From: [REDACTED]
Sent: 05 March 2026 15:48
To: Anna Tidey
Cc: Emily Wade
Subject: RE: DM/25/2662 & 3 - The Toll House, High Street, Lindfield
Attachments: 56HS-001-C-039_01 Section 2nd Floor Window.pdf; 56HS-001-C-010_01 Elevation From West.pdf; 56HS-001-C-034_02 Section Bifold Window.pdf; 56HS-001-C-035_02 Section Sliding Door.pdf; Response for Discharge Conditions 2026-03-05.docx

Subject: Re: DM/25/2662 & 3 - The Toll House, High Street, Lindfield

From: Emily Wade
Sent: 12 February 2026 16:37
To: Anna Tidey <anna.tidey@midsussex.gov.uk>
Subject: The Toll House, High Street, Lindfield DM/25/2663

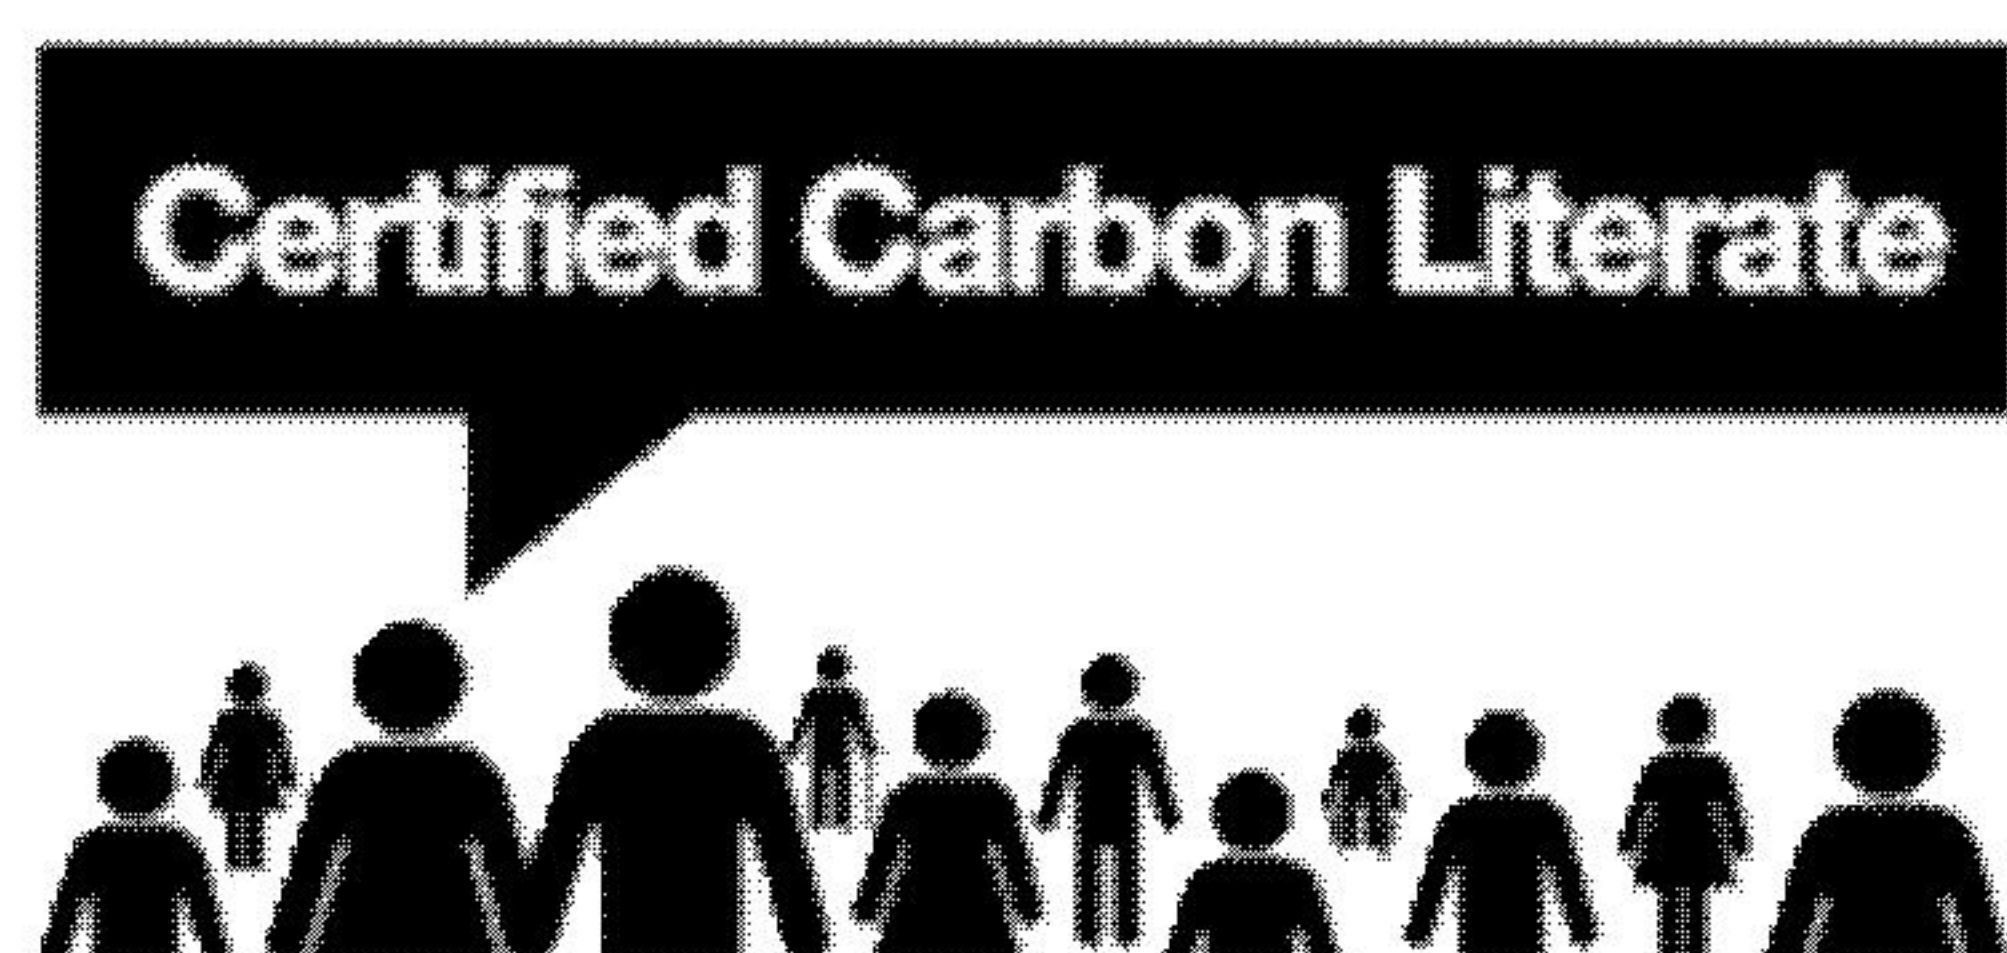
External doors

Please provide details of the materials.
